Public Service Electric and Gas Company

NLR-N86141

REQUEST FOR AMENDMENT
FACILITY OPERATING LICENSES DPR-70 AND DPR-75
UNIT NOS. 1 AND 2
SALEM GENERATING STATION
DOCKET NOS. 50-272 AND 50-311

Proposed Change to Technical Specifications Salem Unit Nos. 1 and 2

FIGURE 6.2-1 CORPORATE HEADQUARTERS AND OFF-SITE ORGANIZATION FOR MANAGEMENT AND TECHNICAL SUPPORT

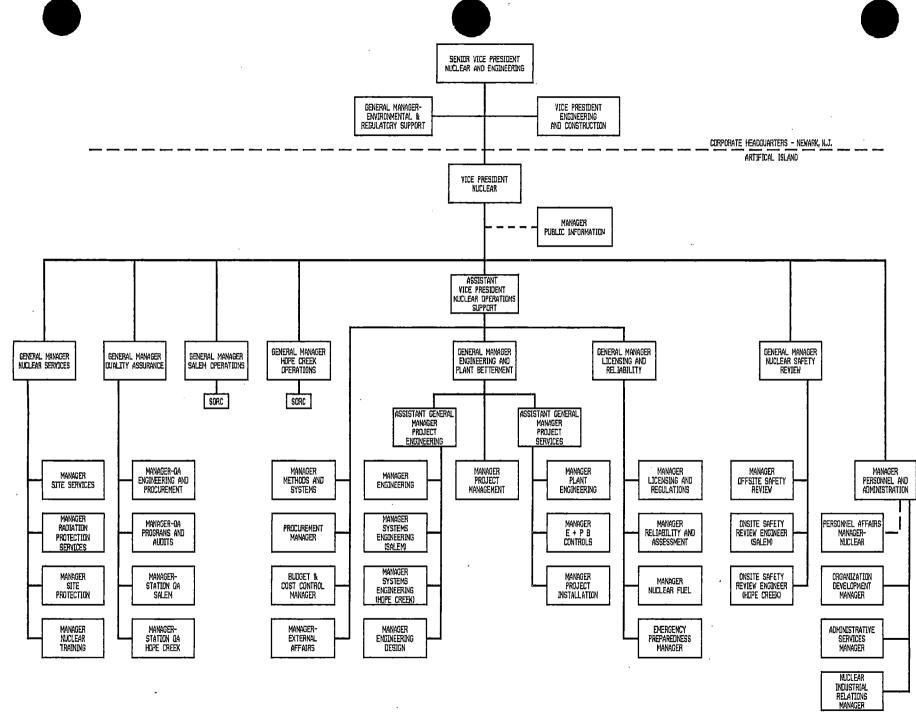
- 3. Figures 6.2-1 and 6.2-2 have been revised to reflect changes in organization, including: establishment of Nuclear Safety Review, deletion of Nuclear Review Board, establishment of Engineering and Plant Betterment, deletion of the slot for Assistant Vice President Nuclear Operations.
- 4. Responsibility for the Fire Brigade training program has been revised. The Manager Site Protection is now responsible for this program.
- 5. SORC membership requirements (Specifications 6.5.1.2 and 6.5.1.3) have been revised to assure that all Salem Operations departments are represented. Included is the one department/one vote concept. All departments section heads (department engineers) will be alternates for their respective department managers. A maximum number of alternates at each SORC meeting will not be required due to the one department/one vote policy.

6.2.1 The offsite organization for facility management and technical support shall be as shown on Figure 6.2-1.
